CITY COUNCIL SPECIAL WORK SESSION
February 28, 2023
6:00 p.m.
Robbinsdale City Hall
4100 Lakeview Avenue North

RE: Blue Line Extension Light Rail

METRO Blue Line Extension – Objective Review & Options Analysis

Robbinsdale BLRT Evaluation

Exhibit 1: Station Option A1 (Image with notes provided by METRO Blue Line Extension Project Team)

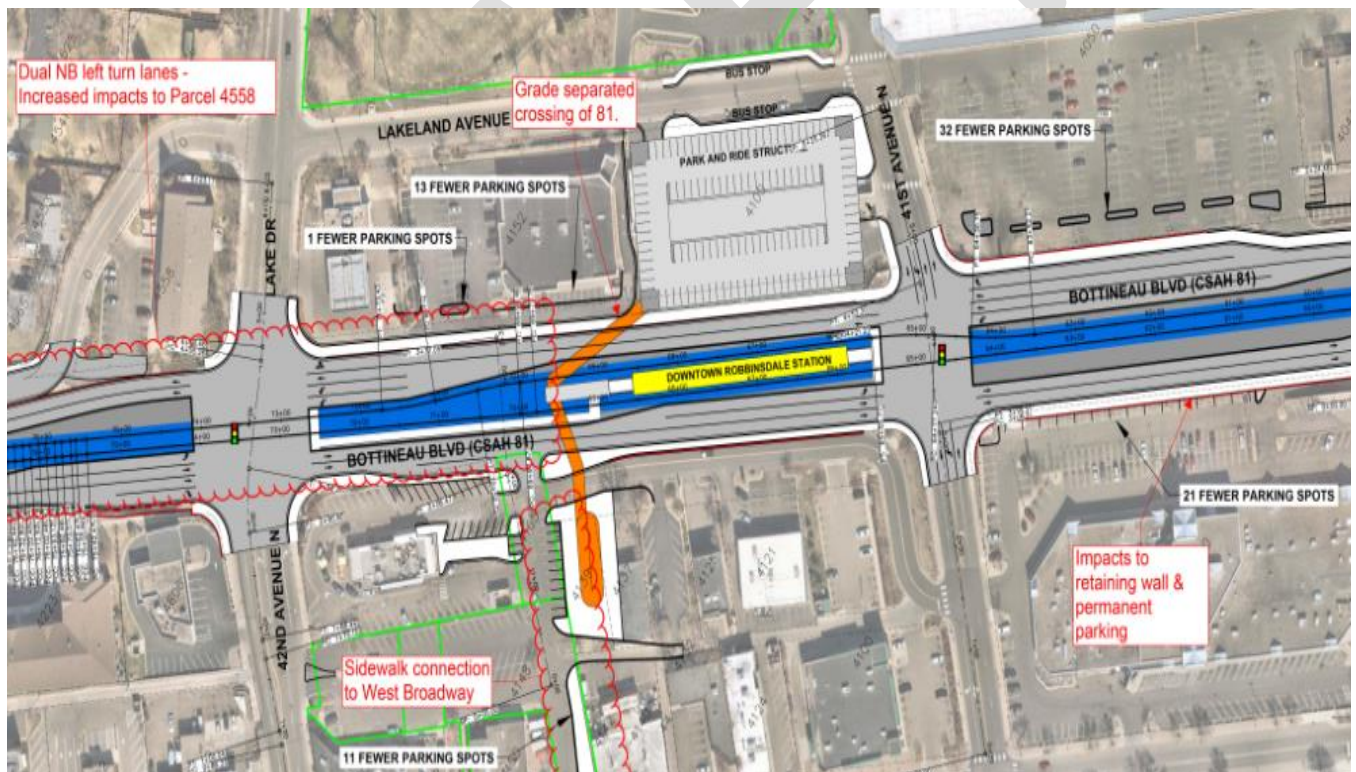
Station Option A1 Includes one center-loading platform north of 41st Avenue, as shown in **Exhibit 1**. This option would include a pedestrian bridge and an access tower connection across CR 81, and results in 14 fewer parking stalls north of the parking garage, 32 fewer stalls at lower Robin Center, 21 fewer stalls at upper Robin Center, 11 fewer stalls at Ace Hardware, and a parking lot reconfiguration at the McDonald's.

Exhibit 2: Station Option A2 (Image with notes provided by METRO Blue Line Extension Project Team)

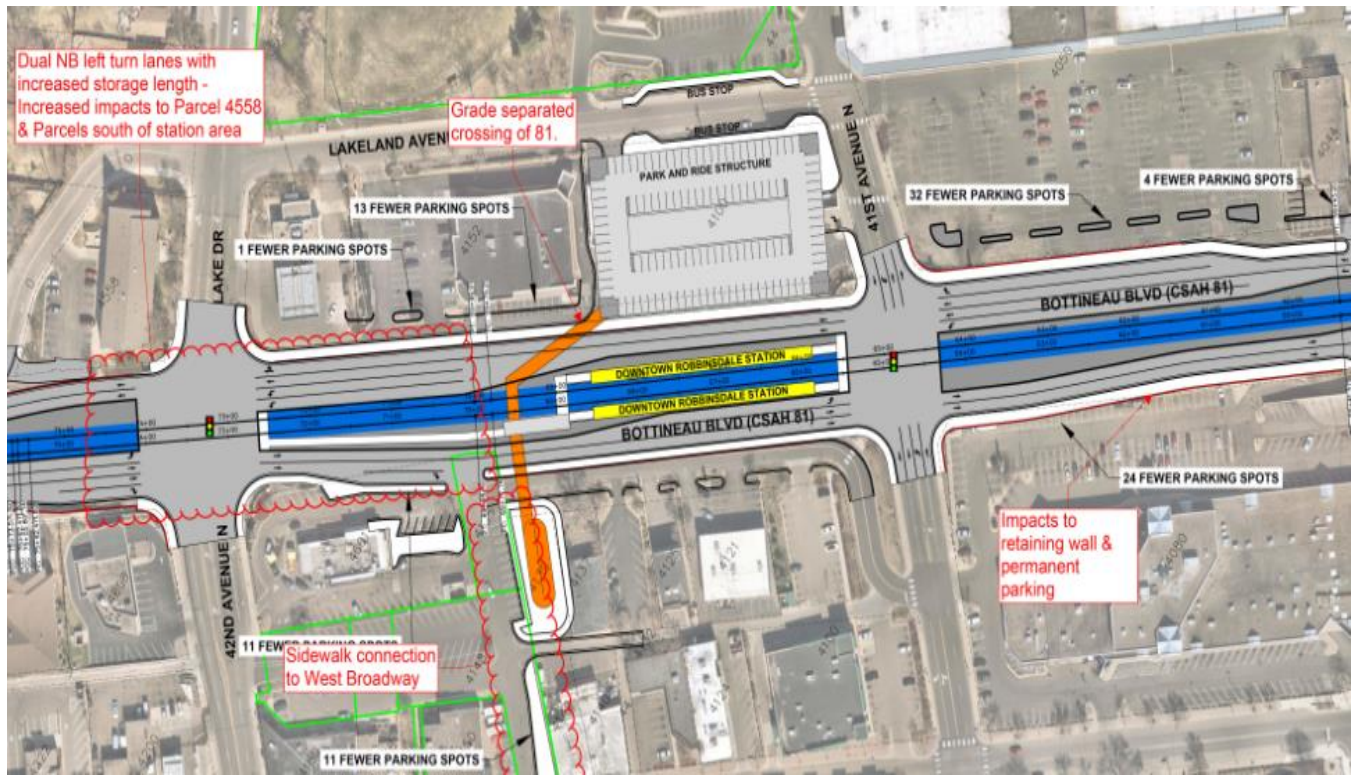
Station Option A2 is variation of Station Option A1 that includes two side-loading platforms north of 41st Avenue, as shown in **Exhibit 2**. This option includes a pedestrian bridge and access tower connection across CR 81, and results in 14 fewer parking stalls north of the parking garage, 36 fewer stalls at lower Robin Center, 24 fewer stalls at upper Robin Center, 22 fewer stalls at Ace Hardware, and a parking lot reconfiguration at the McDonald's.

Exhibit 3: Station Option B (Image with notes provided by METRO Blue Line Extension Project Team)

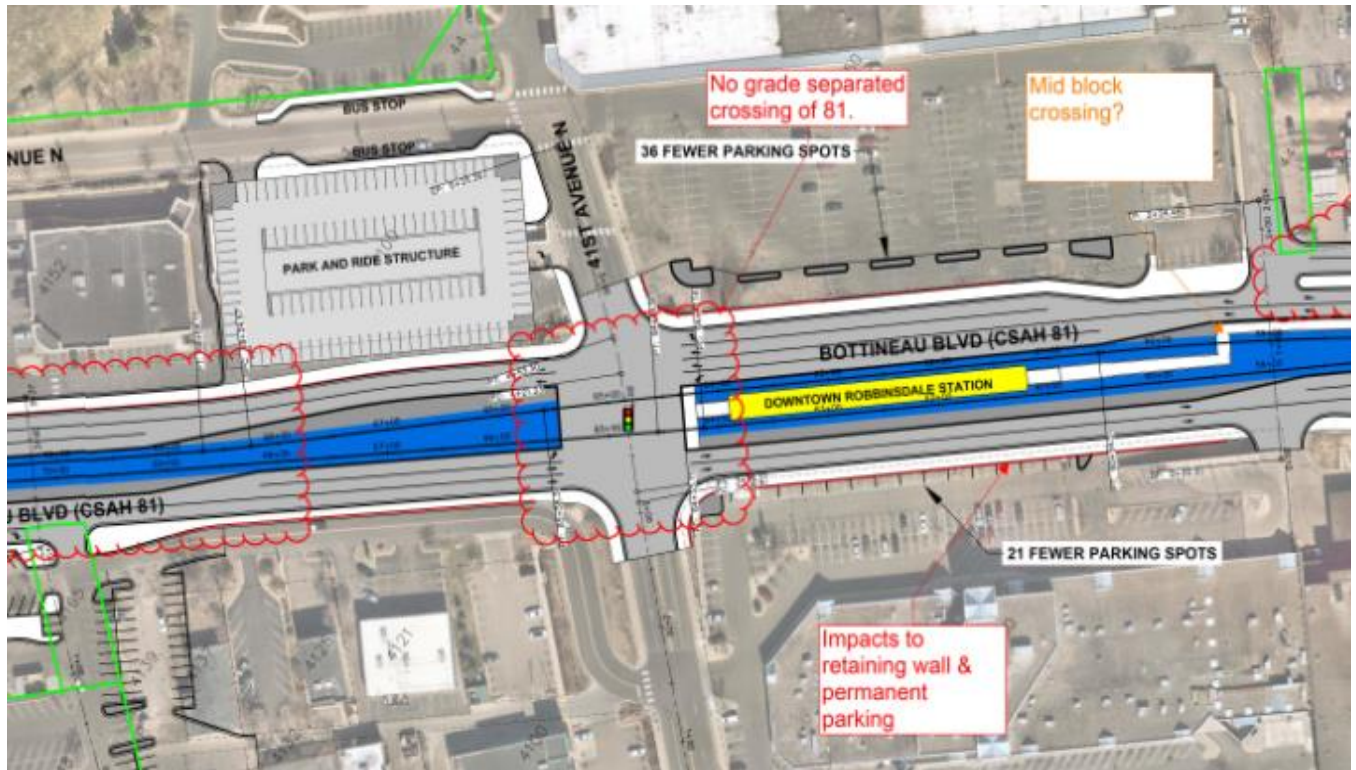
Station Option B Includes one center-loading platform south of 41st Avenue, as shown in **Exhibit 3**. This option does not include pedestrian bridge connection across CR 81, and would result in one parking stall removed north of the parking garage, 36 fewer stalls at lower Robin Center, 21 fewer stalls at upper Robin Center, and a parking lot reconfiguration at both Ace Hardware and McDonald's.

Exhibit 4: Station Option C (Image with notes provided by METRO Blue Line Extension Project Team)

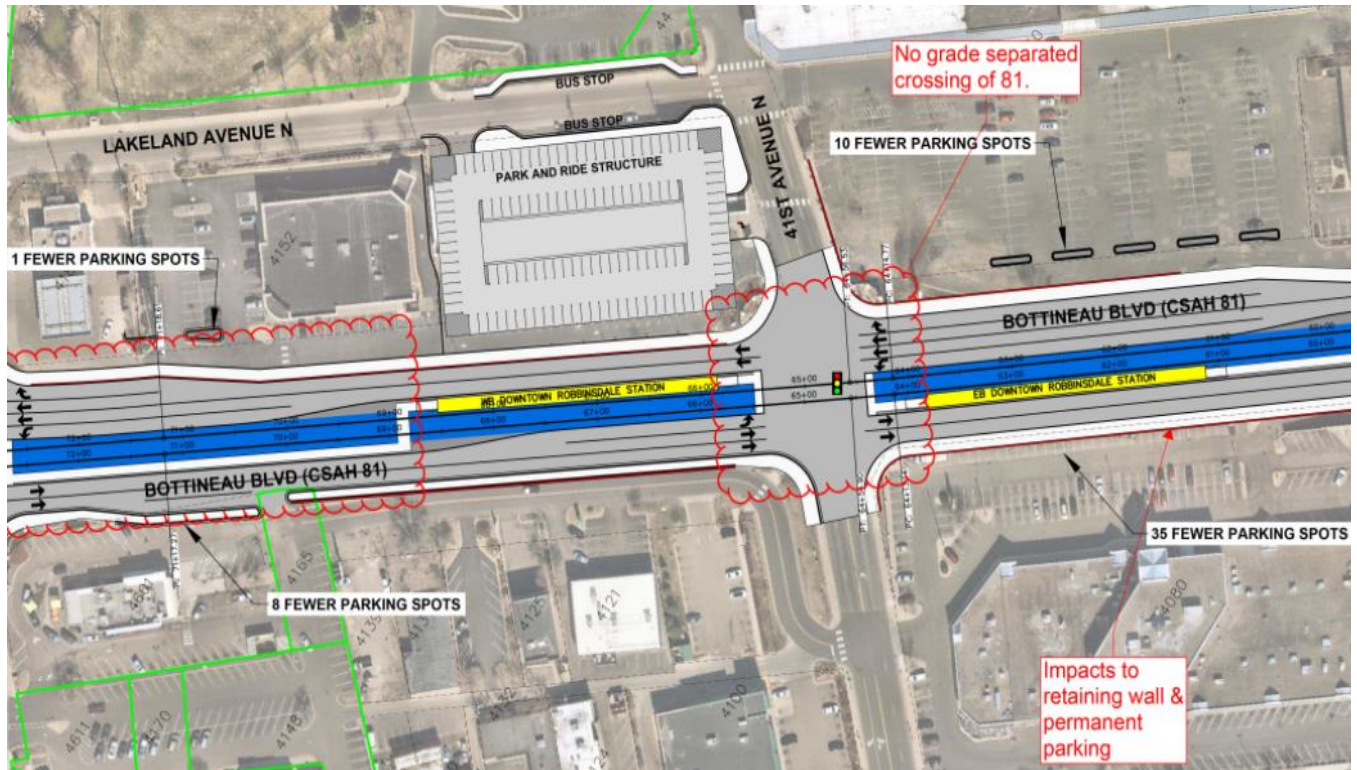
Station Option C includes platforms split across 41st Avenue, as shown in **Exhibit 4**. This option would not have a pedestrian bridge connection across CR 81, and would result in 1 parking stall removed north of the parking garage, 10 fewer stalls at lower Robin Center, 35 fewer stalls at upper Robin Center, and 8 fewer stalls at the McDonald's.

Exhibit 5: Station Option D (Image with notes provided by METRO Blue Line Extension Project Team)

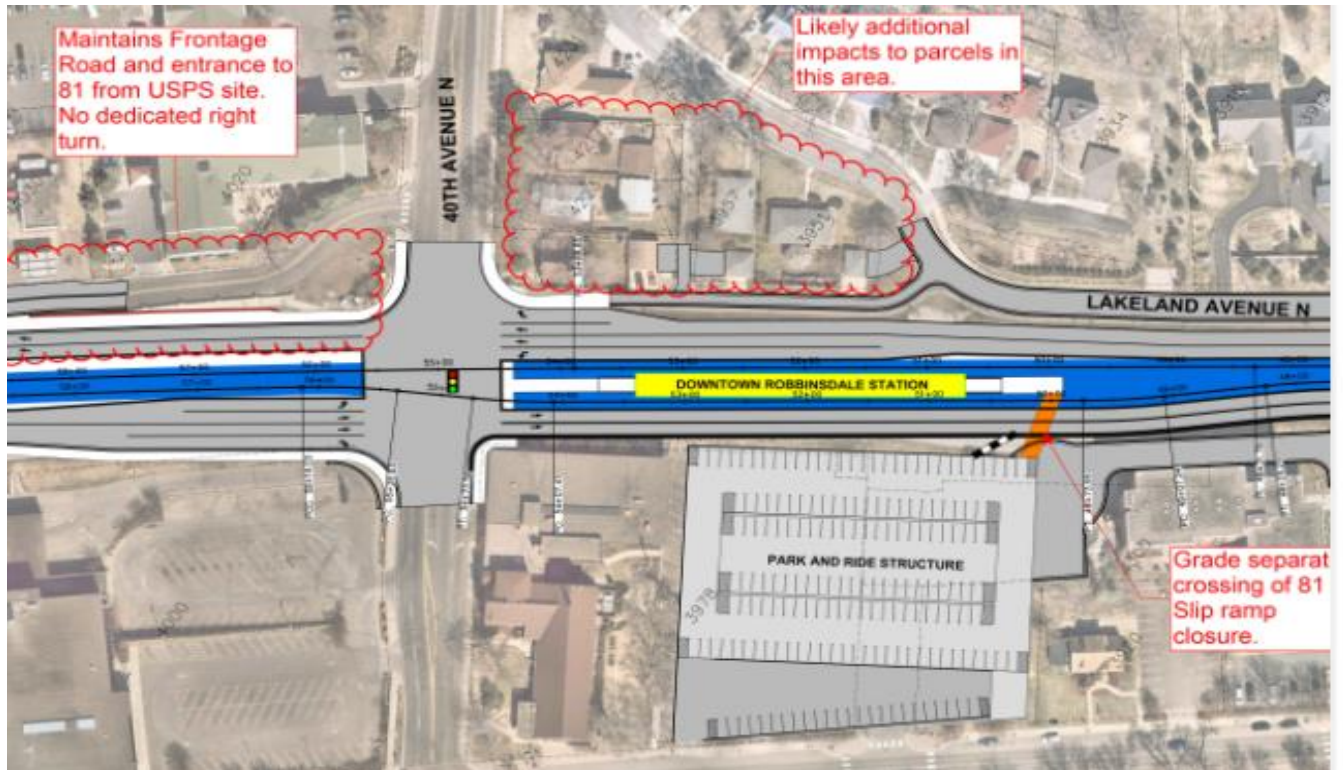
Station Option D includes one center-loading platform south of 40th Avenue, as shown in **Exhibit 5**. This option includes a pedestrian bridge connection across CR 81 and would result in 36 fewer parking stalls at lower Robin Center. It should be noted that the City has approved a redevelopment on the proposed garage site and has identified a potential alternative garage site one block south at 39th Street.

Exhibit 7: SBL at Lakeland Avenue North to Twin Lake - Alternate Route

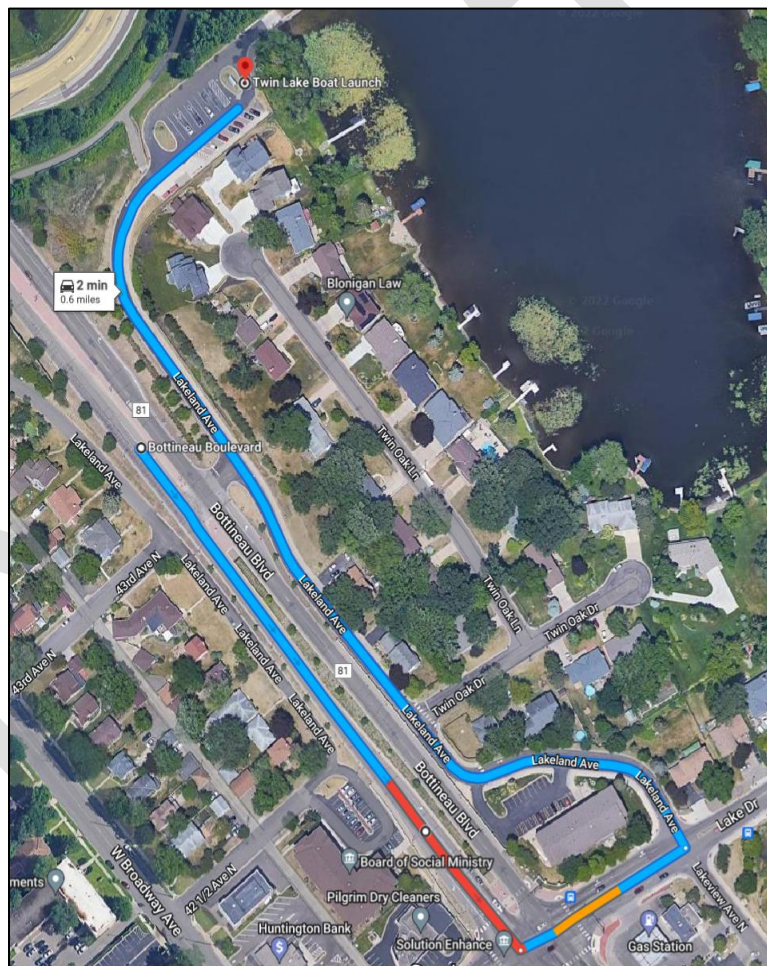
The SBL at Lakeland Avenue N to Twin Lake remains in the Future Build Vissim model, but does not have a route or any vehicles making the movement. The Future No Build Vissim model maintains the SBL movement, but similarly has no volume to the boat ramp. StreetLight Data was used to gather 2019 existing turning movement volumes. 41 SBL turning vehicles are observed in the daily volume set analyzed. Between 11:00am and 7:00pm, the highest hourly volume making a SBL movement is 4. On weekends, 18 average SBL turning vehicles were observed between 1:15pm and 7:00pm.

If the movement is removed, this location has existing access that would be maintained from Lake Drive and make a logical detour that could be utilized with vehicles pulling trailers. (See **Exhibit 7.**) While this is a low volume movement, the route does provide access to several homes.

Exhibit 8: 42nd Avenue 7:03 (AM)

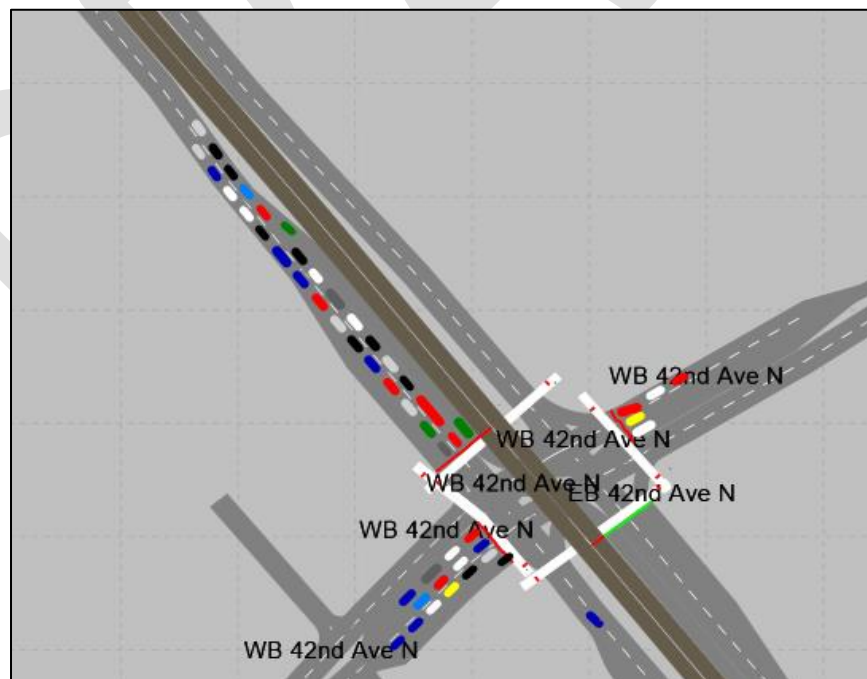
Queues are observed in both the AM and PM peak hour Build Vissim models. Queues tend to clear within one signal cycle length and dissipate quickly. In the AM peak hour, queueing was seen SB at 42nd Avenue and 36th Avenue. See **Exhibit 8** and **Exhibit 9**.

Exhibit 10: 40th Avenue 16:21 (PM)

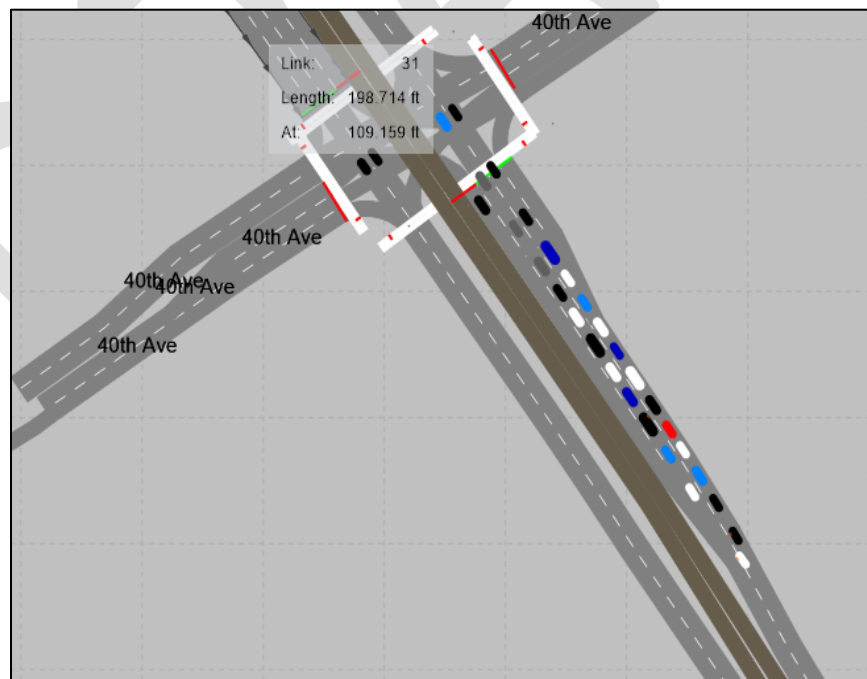
In the PM peak hour, queuing was observed NB at 40th Avenue and 41st Avenue. See **Exhibit 10** and **Exhibit 11**.

Exhibit 20: CR 81/42nd Avenue (Option 1)

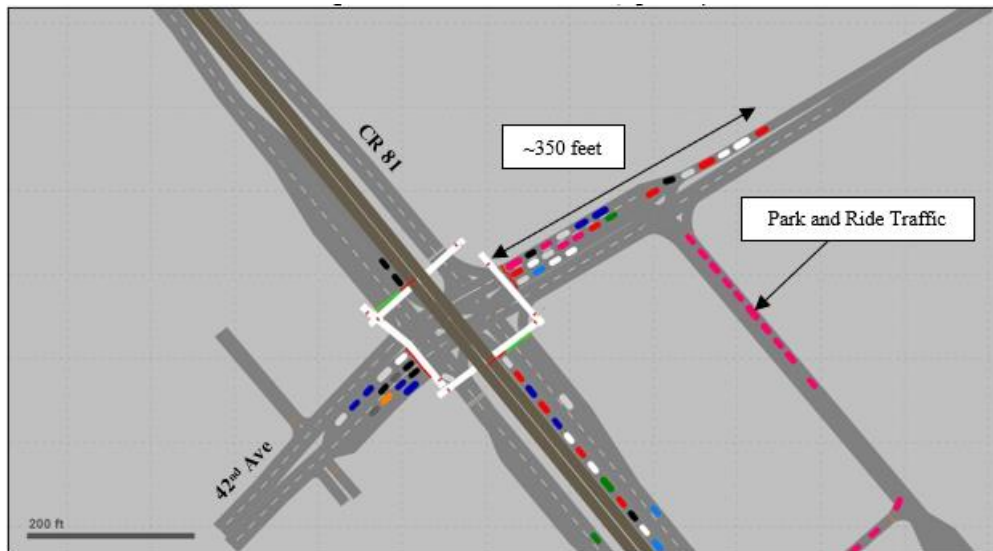
Avenue intersection and limit opportunities for Park-and-ride vehicles to turn onto 42nd Avenue as indicated in **Exhibit 20**.

The westbound approach at 36th Avenue operates similarly (LOS F) across all four options and reported delay is related to the proposed signal phasing as eastbound and westbound are modelled as essentially split phased. No Park-and-ride traffic is assumed to head south on CR 81 and therefore operations at this intersection are unrelated to any park-and-ride options.

Exhibit 22: CR 81/41st Avenue (Option 2)

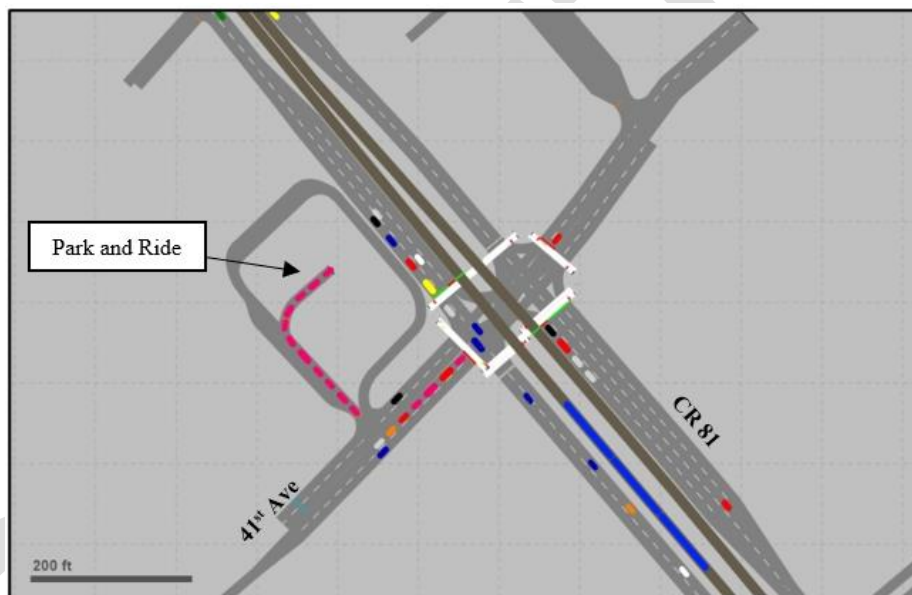
For Option 2, all intersections operate at LOS D or better overall during the design year PM peak hour. Only a couple of movements and approaches operate at or worse than LOS E, including the westbound approach at 36th Avenue. As noted previously, due to the location of the park-and-ride for Option 2, it is assumed that Park-and-ride traffic to the west (42nd Avenue) and south (Noble Avenue) would utilize Broadway Avenue which reduces the impact on CR 81. The eastbound left turn at 41st Avenue would operate at LOS E due to increased demand heading north or east from the park-and-ride. The associated queue would extend through the assumed park-and-ride access point on 41st Avenue which could restrict the ability for traffic to exit the Park-and-ride as indicated in **Exhibit 22**. This may be at least partially mitigated by providing dual eastbound left turn lanes and/or modifying the signal timings to extend the eastbound phase.

Exhibit 24: CR 81/42nd Avenue (Option 3)

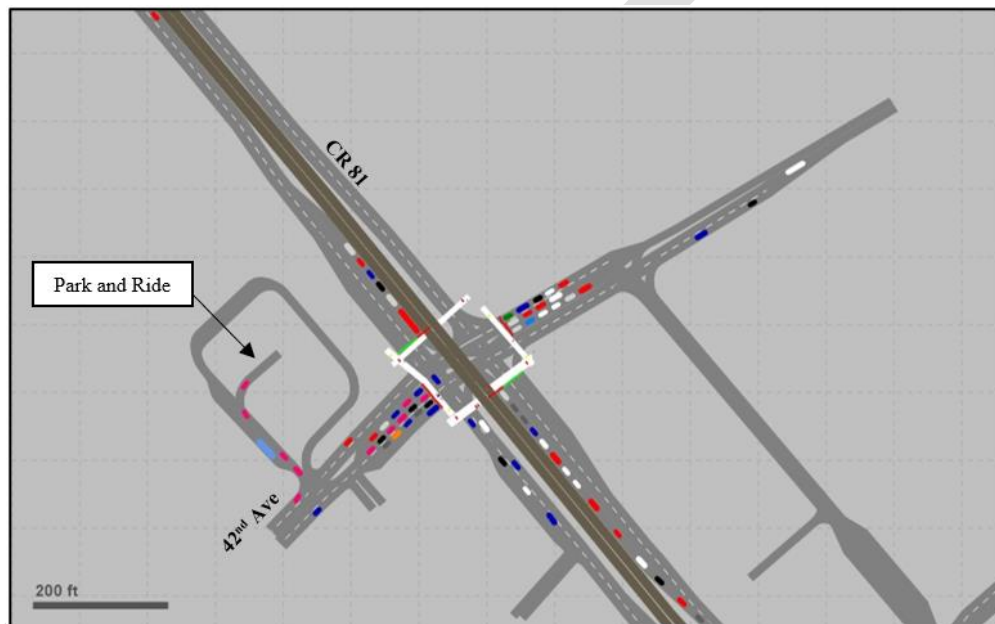
For Option 3, all intersections operate at LOS D or better overall during the design year PM peak hour. One approach operates at LOS F (westbound at CR 81/36th Avenue) and both the eastbound and westbound approaches at 42nd Avenue operate at LOS E. The eastbound left (LOS F) and eastbound through (LOS E) turn movements degrade in comparison to previous options due to the location of the park-and-ride and associated traffic to the north and east. However, the associated queues for these movements do not extend through the assumed park-and-ride access point on 42nd Avenue as indicated in **Exhibit 24**. As half of the park-and-ride traffic is assumed to head west on 42nd Avenue, it removes this traffic from CR 81 entirely.
